**FINDINGS AND RECOMMENDATION
OFFICE OF PLANNING AND ZONING
ANNE ARUNDEL COUNTY, MARYLAND**

CASE NUMBER: 2024-0062-V

The applicants are requesting a variance to allow a dwelling addition (garage and second floor living space) with less setbacks than required on property located at 621 Ayrlie Water Road in Gibson Island.

VARIANCE PLAN
GIBSON ISLAND ~ LOT 285
 621 AYRLE WATER ROAD, GIBSON ISLAND, MD 21036
 TAX MAP 0034 - GRID 0007 PARCEL 0030 DISTRICT 3RD
 JANE PARCEL COUNTY, MARYLAND
 DATE: FEB. 8, 2024 PROJ. NO. 09M4623 SHEET 1 OF 1

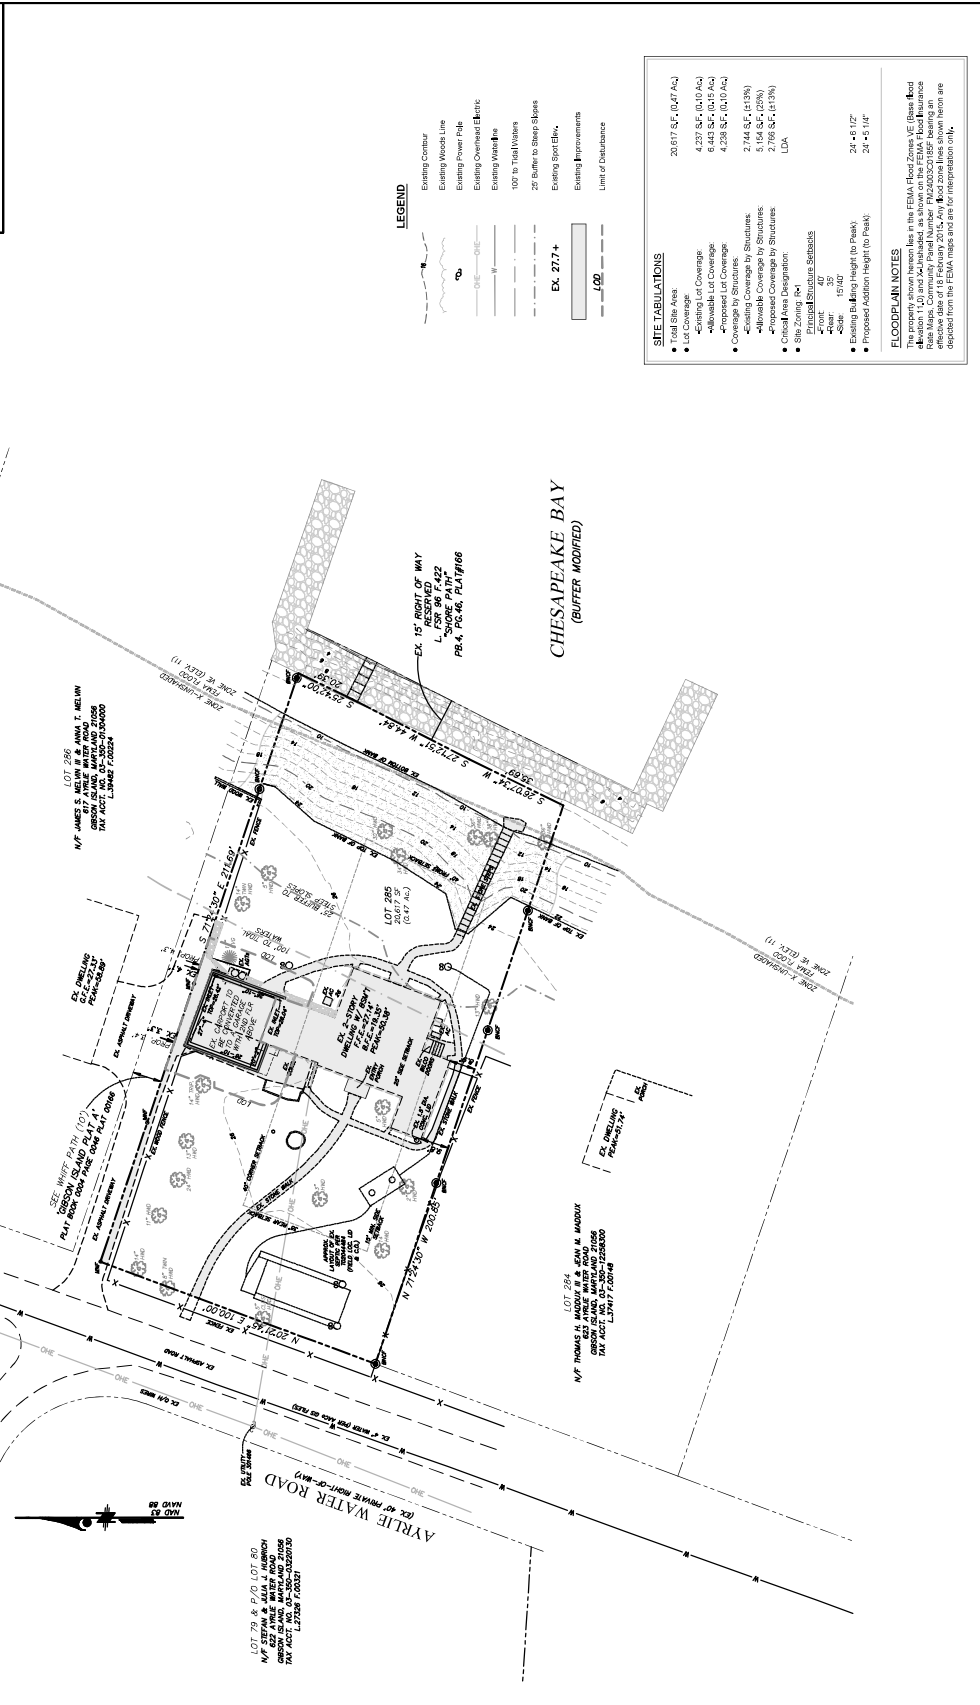
² While the SDAT classifies this property as "waterfront", the definition of "Waterfront lot" in the County Code "means a lot that (i) abuts the mean high-water line or (ii) abuts platted land owned by a homeowner's association or the County that abuts the mean high-water line and, through agreements or conveyances, has the right to function as a waterfront lot." Plat A for Gibson Island, recorded in 1925, shows a reserved area along the entire waterfront. It is noted that the front and rear setbacks shown on the site plan should be reversed in location.

§ 18-4-501 of the Anne Arundel County Zoning Code requires a principal structure in an R1 District to be set back a minimum of 40 feet from the corner side lot line with a combined side lot line setback of 40 feet. The proposed addition is located as close as 3.4 feet from the north corner side lot line widening to 4.3 feet, necessitating a variance of 37 feet to corner side setback. The south side of the existing dwelling is as close as 8.9 feet from the side lot line therefore, the combined side setback is proposed to be a total of 12.3 feet necessitating a variance of 28 feet to the 40-foot combined side setback requirement.

The existing carport is currently nonconforming as to setbacks and appears to have been longstanding. Replacement in kind of the carport would be allowed under §18-2-303 without the need for a variance. Redevelopment of a property generally provides an opportunity to conform to the Code or lessen a required variance. This Office recognizes that the corner side setback line is located through the existing dwelling making compliance with the Code impossible for construction of an addition on the north side. However, the side load garage will provide both a single garage door and a double-wide garage door; the overall dimensions of the proposal are larger than the typical two-car residential garage (24 feet by 24 feet); and a second story approximately 24 ½ feet in height to the peak will create mass and tower over the path right-of-way only three feet from the lot line.

As the request is excessive and unwarranted it cannot be considered to be the minimum necessary to afford relief.

Based upon the standards set forth in § 18-16-305 of the Code under which a variance may be granted, this Office recommends *denial* of a zoning variance to § 18-4-701 to allow the proposed dwelling addition (garage and second story living space) to be constructed as close as three feet from the north side lot line as shown on the site plan.

PROPOSED ELEVATIONS

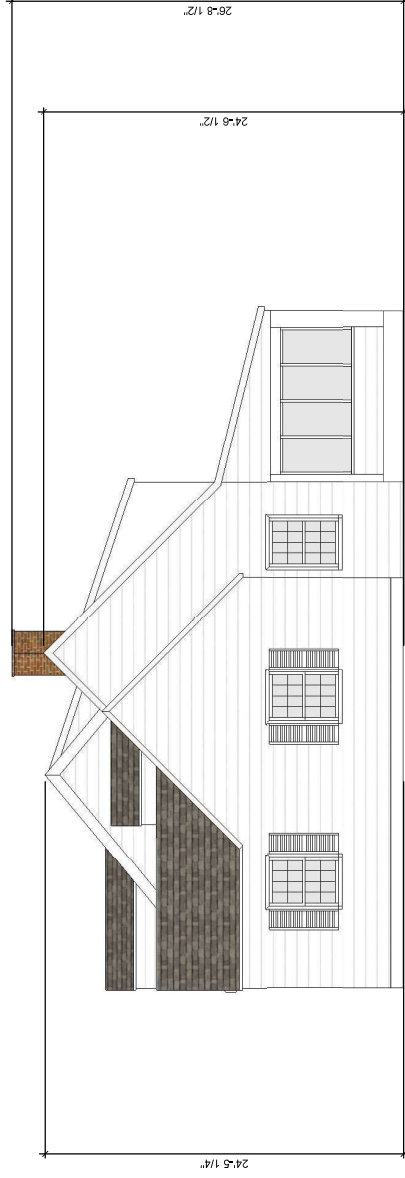
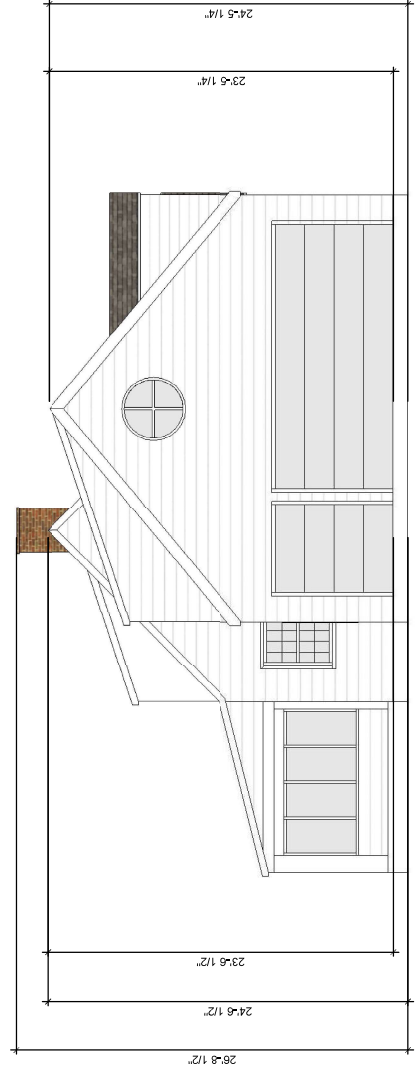
The **Zoning Administration Section** notes that the requested variances are not accurately described. The lot is undersized for the R1 District. § 18-2-301(f) allows a single-family detached dwelling on a lot that does not meet the area or width requirements of the Code to be expanded if the expansion is set back at least 25' from the front and rear lot lines and seven feet from side lot lines and does not exceed 35' in height. Therefore, the 40' combined setback does not apply and a variance to the 40' combined setback is not required. However, this property abuts Sea Whiff Path and is considered to be a corner lot. § 18-4-501 provides a minimum 40' setback from a corner side lot line. When there are competing provisions in the Code, the more specific provision applies. Therefore, a 37' variance to the 40' corner side setback is required.

The site plan must label the height of the proposed addition. Given that setback variances could have visual impacts on adjacent properties, the applicant should explain how those potential impacts have been minimized. The proposed addition appears to be even taller than the existing dwelling, and it appears that the potential visual impacts could be minimized by reducing the height to match the existing dwelling height. In order for a variance to be granted, the applicant must demonstrate and the Hearing Officer must find that the proposal complies with the variance standards provided under Section 18-16-305, including that the request is the minimum necessary to afford relief.
